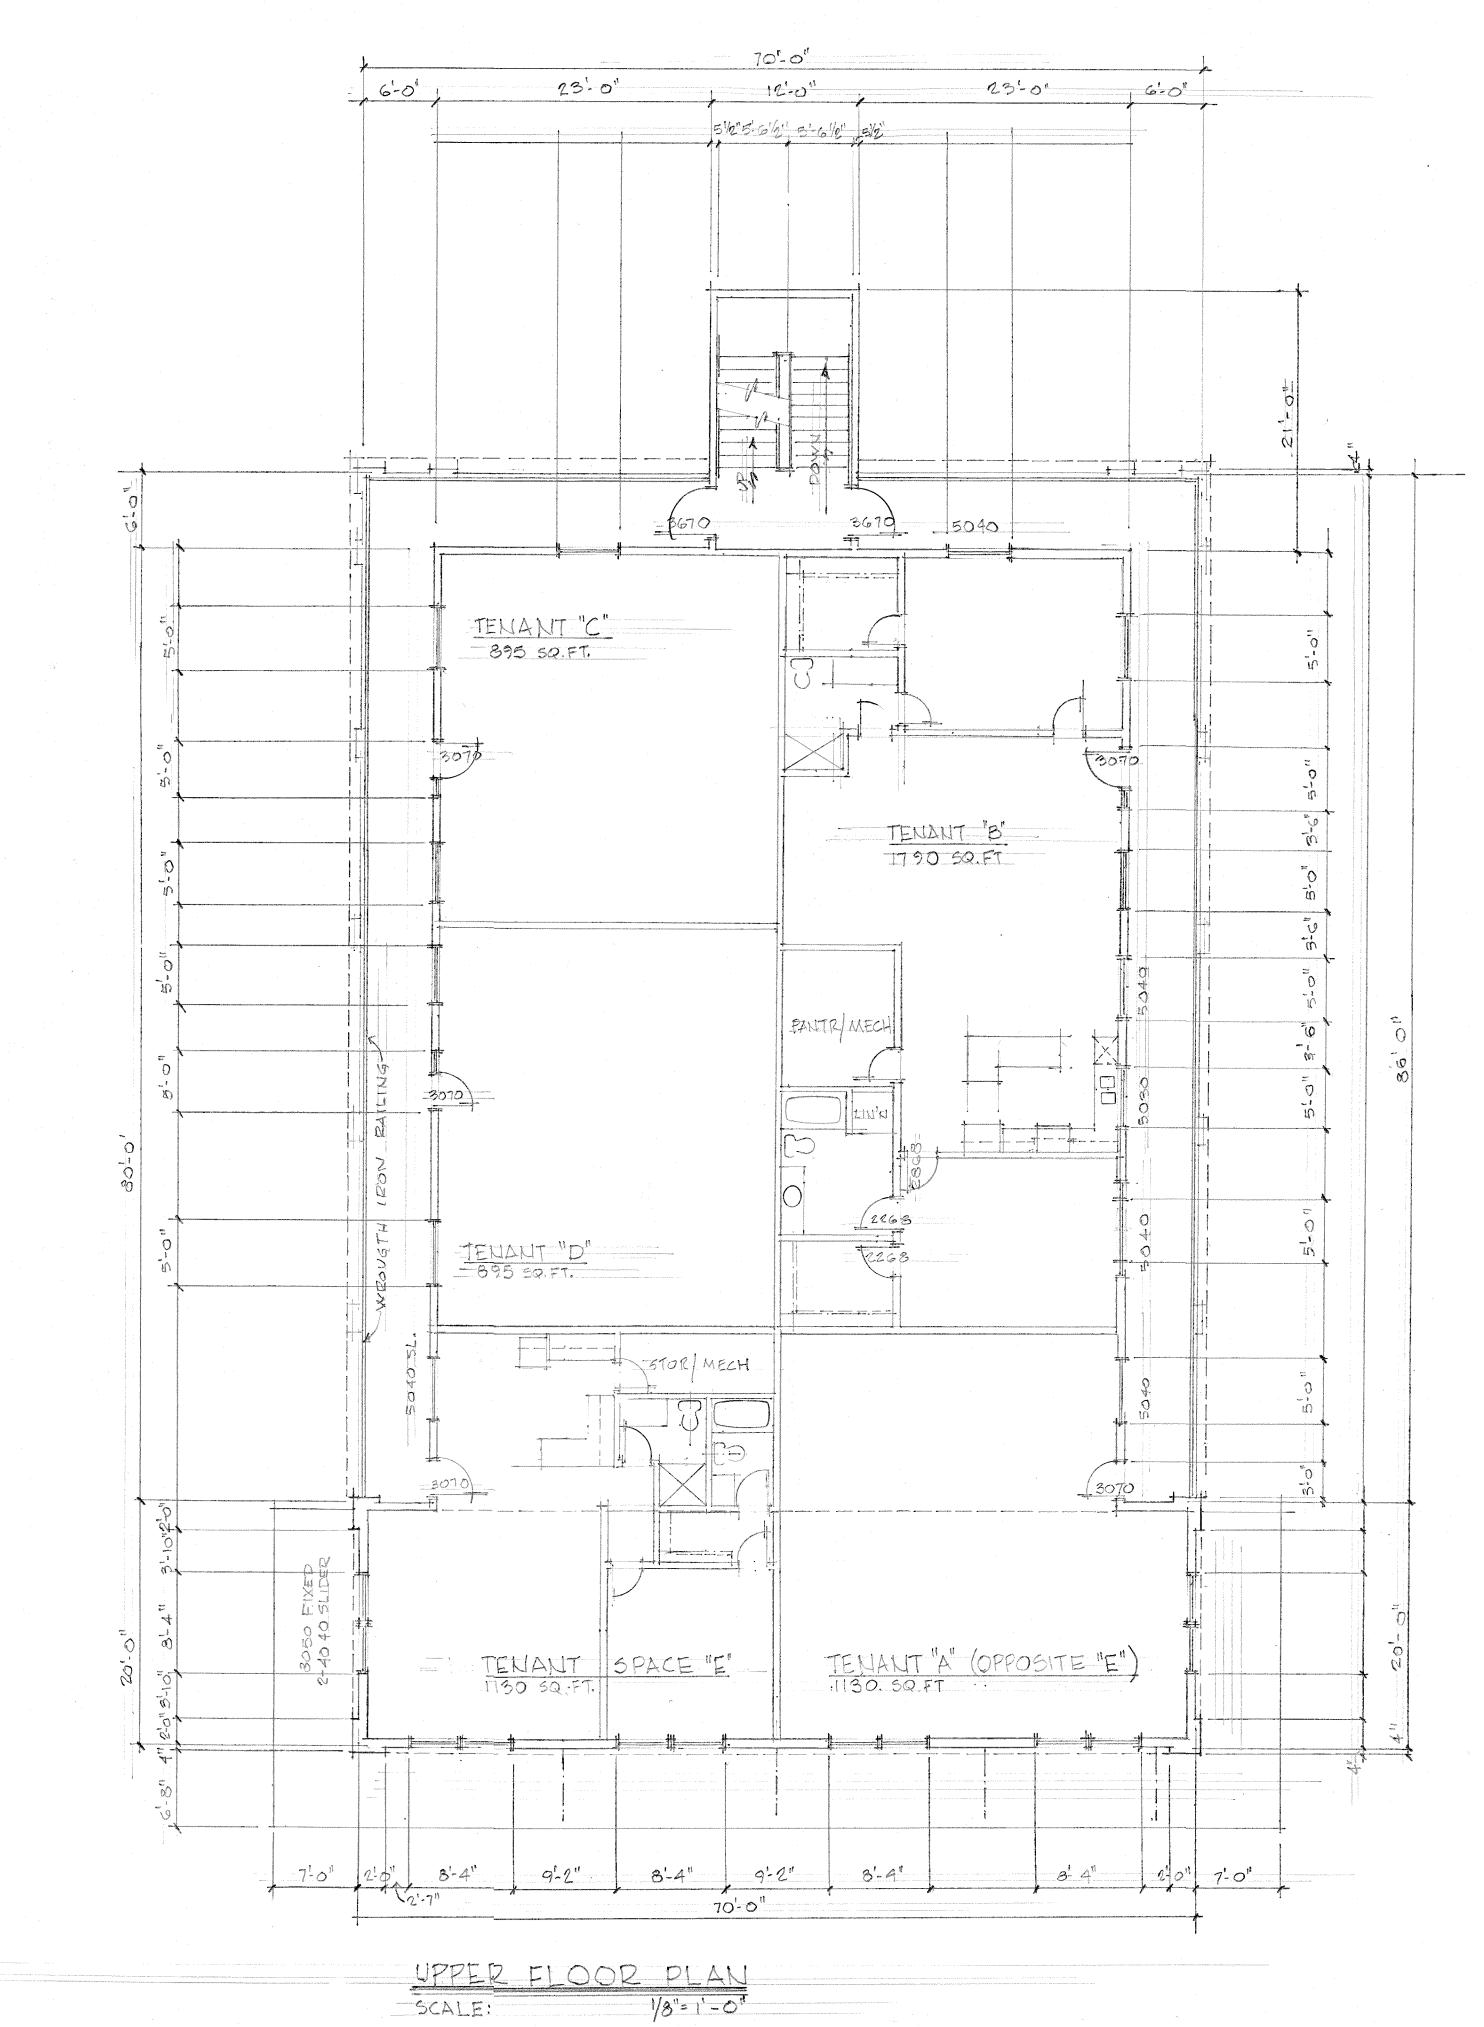
5,89°23'00"E. 108,35' SEPTIL DEAIL FIELD MEW APARTMENTS URFL. 60 150 18-0", 10-0 64'-0" Sidewalk should be right at property line and should be adjacent to the building front. Any way to make the 10 ft sidewalk and 6 ft bike path work here? 70'-0" Bike Path Shoulder width including parking, curb, and gutter is planned to be 18.5 feet Angled parking is planned for this area. Can you please show 45 degree angled parking instead? WIFLOURING Q"C.
PEAR TREE (TYP.) STREET E 2300 NORTH STREET SITE PLAN OCALE: 1'= 20'-0"

Please provide building colors WEOUGTH FON PAILING TOPOFTRUSS (EL. 123:0" \$ 128'6" UPPER CL. 124-0" LOW CLG. 121-0" = R STANDING SEAM MIL. ROOF UPPER FL. EL. 112:0' FINISH FL. EL. 100 Will bottom of windows be glass or will it match the cast iron appearance? if so, please show on Will the base of the building incorporate a cast iron appearance? If so please show on plans. EAST EXTERIOR ELEVATION
